CITY OF LATHRUP VILLAGE
PLANNING COMMISSION AGENDA

Site Plan Review

Site: 27208-27260 Southfield Road
Applicant: Lathfield Investments LLC
Plan Date: 4/7/2020
Zoning: MX- Mixed Use District
Parcel ID: 24-13-357-001; 24-13-357-002; 24-13-357-008
Proposal: 27206-60 Southfield Mixed Use

Site: 28600-28690 Southfield Road
Applicant: Lathfield Partners, LLC
Plan Date: 04/07/2020
Zoning: MX – Mixed Use District
Parcel ID: 24-13-105-001; 24-13-105-019; 24-13-105-017
Proposal: 28600-90 Southfield Mixed Use

**ARCHITECTURAL
SITE PLAN**

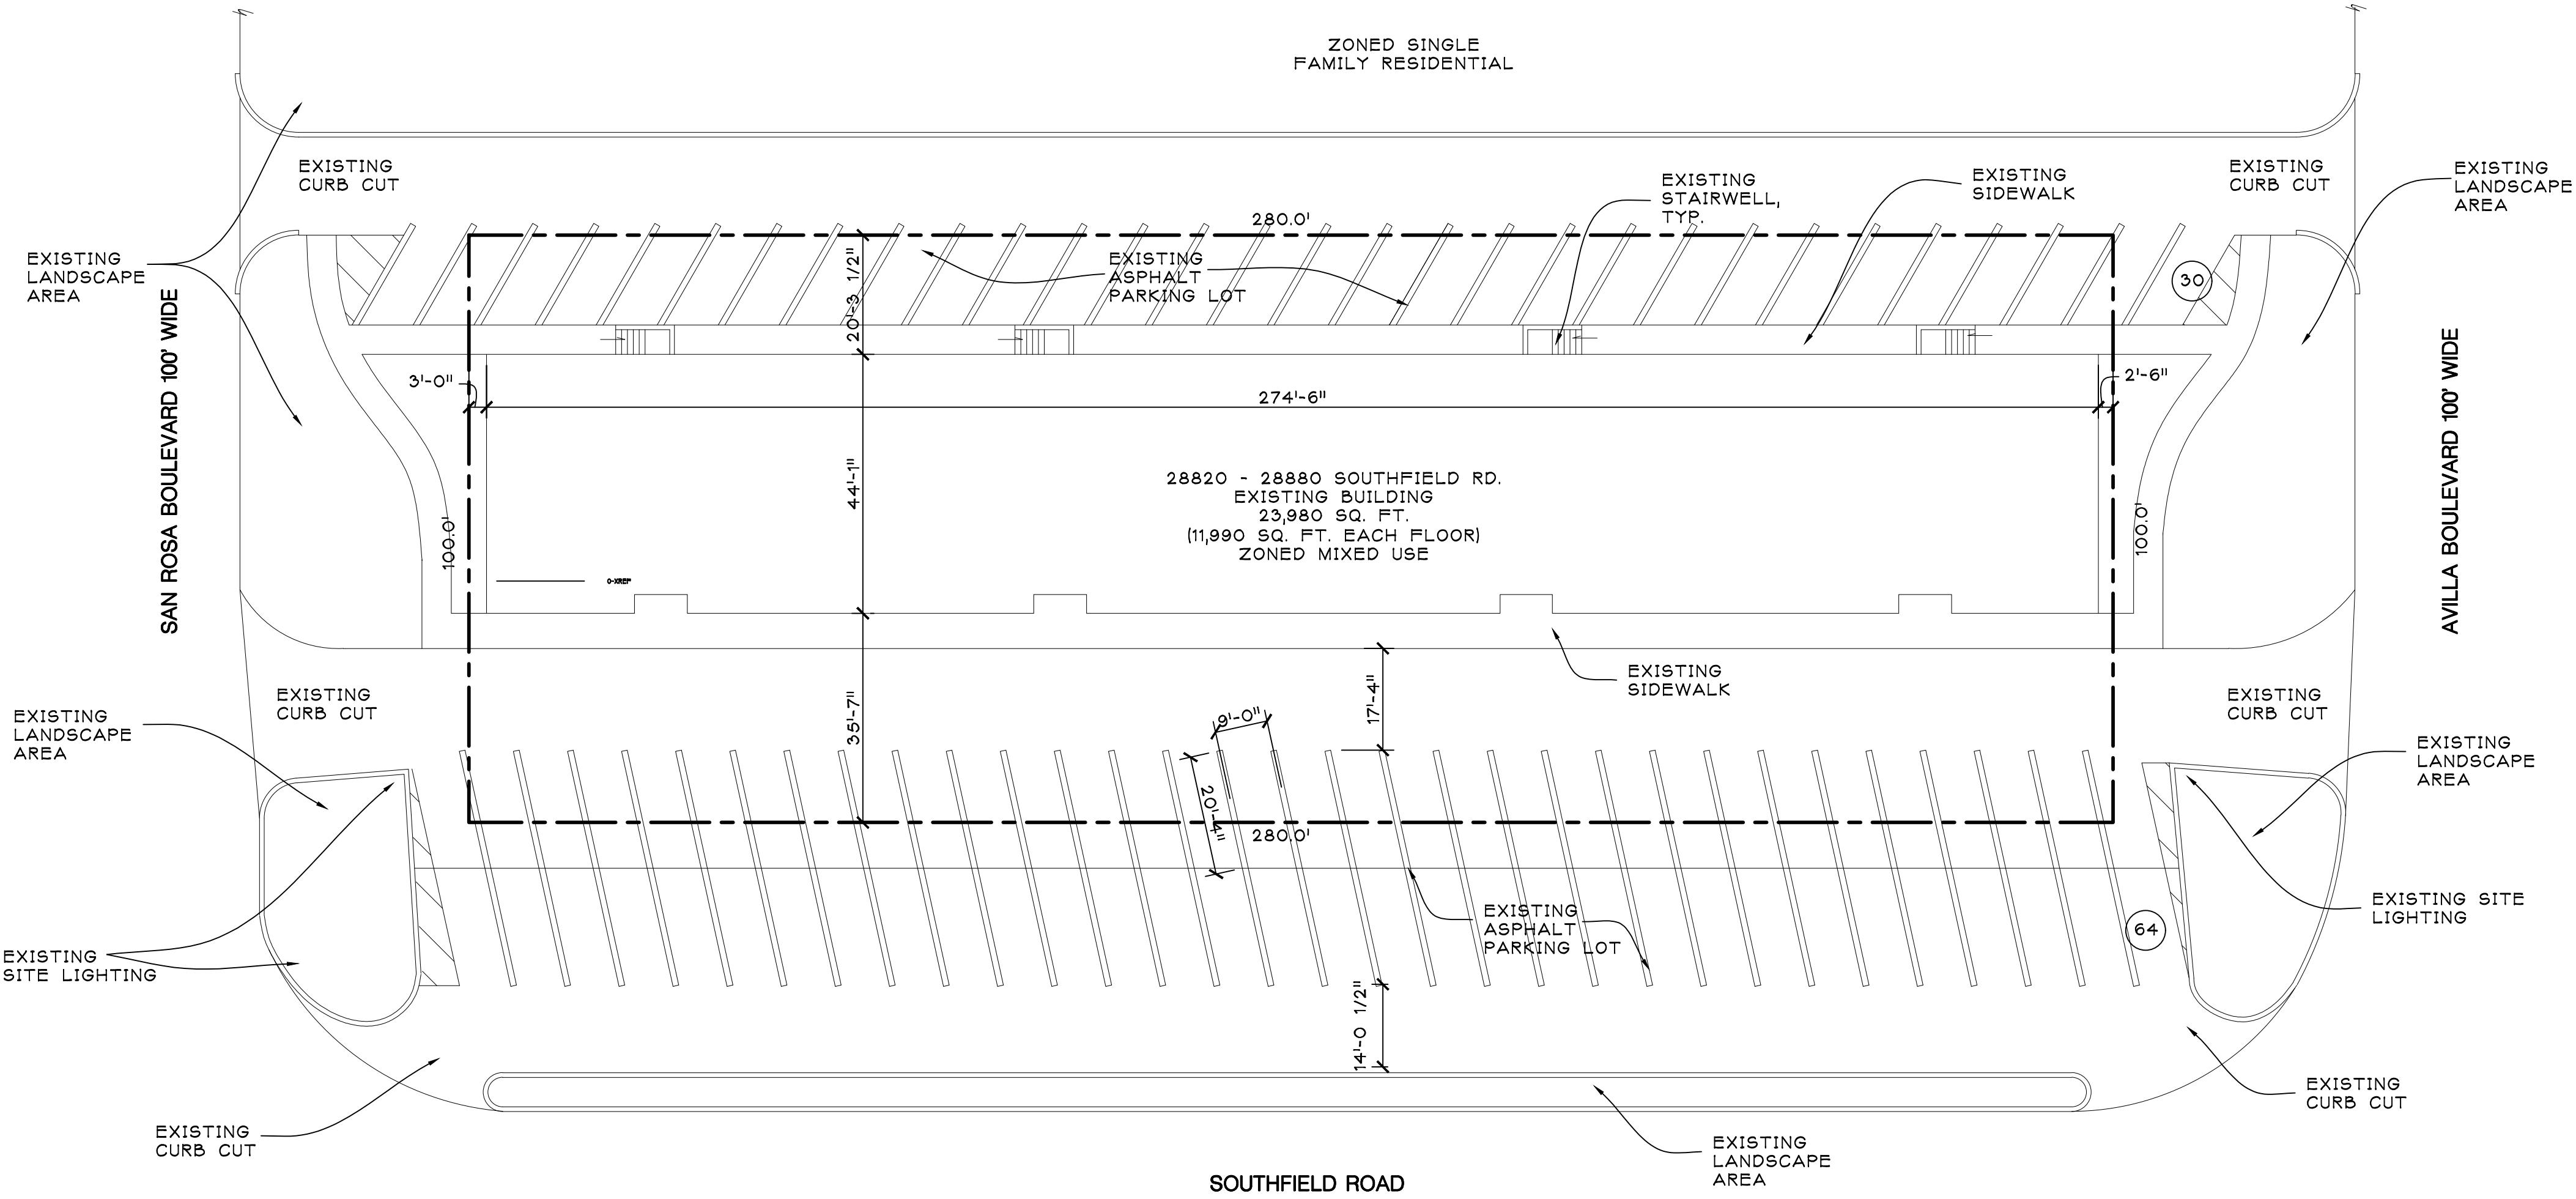
3. **Adjacent land uses.** Adjacent uses include retail and commercial north, south, and west of the site. East of the site, adjacent to the public alley, is residential property. **The applicant shall note the correct width of the alley.**

8. **Loading.** Delivery vehicle space is required for sites that have buildings with a floor area over 3,000 square feet. **The proposed building is 23,980 square feet; therefore, one 40' x 10' space is required to be provided on site; no loading space is shown on the proposed plan.**

10. **Waste & Rubbish.** No dumpster is noted on the site plan; however, there is an existing dumpster on site, in an area designated as parking on the site plan. **The applicant shall confirm that the existing dumpster will be removed. If the dumpster is to remain, the number of spaces will need to be adjusted and the following standards will apply:**

- a. **Dumpster.** The owners and occupants of every building shall provide proper receptacles for said waste and keep receptacles clean and not exposed on the grounds outside of a building. **Applicant does not indicate a location for a dumpster or waste receptacle for the building.**

- b. **Location.** Dumpsters shall be permitted in the side or rear yard, provided that no dumpster shall extend closer to the front of the lot than any portion of the principal structure and provided further that the dumpster shall not encroach on a required parking area, is clearly accessible to servicing vehicles, and is located at least ten (10) feet from any building. Dumpsters shall comply with the setback requirements for the district in which they are located. Dumpsters shall be located as far as practicable from any adjoining residential district. **No dumpster located on the plan.**

- c. **Screening.** All refuse bins located in the city must be enclosed or screened from public view. Such screening shall consist of a wall or fence not less than one (1) foot higher than the height of the refuse bins placed therein, which completely conceals its contents from public view, but in no instance shall such screening be less than six (6) feet in height on three (3) sides. The fourth side of the dumpster screening shall be equipped with an opaque, lockable gate that is the same height as the enclosure around the other three sides. **No dumpster located on the plan.**

- d. **Bollards.** Bollards (concrete-filled metal posts) or similar protective devices shall be installed at the opening to prevent damage to the screening wall or fence. **No such bollards are indicated on the site plan.**

- a. Landscape Plan. No landscape plan was submitted with the application. Existing landscaped areas are shown, but existing trees, shrubs, and plant species are not indicated on the site plan. **Applicant shall provide a landscape plan to show existing and proposed landscaping on the site, if any.**

- b. Minimum landscaped area of 5%. **Applicant appears compliant but landscaped area coverage not indicated on the plan. Applicant shall confirm that at least 5% of the lot is landscaped.**

12. **Screen Wall.** Section 5.5 of the zoning ordinance outlines barrier wall requirements for CV lots that abut residential (R-1 or R-2) lots. The existing wood fence is nonconforming; the Planning Commission may wish to discuss the following standards with the applicant:
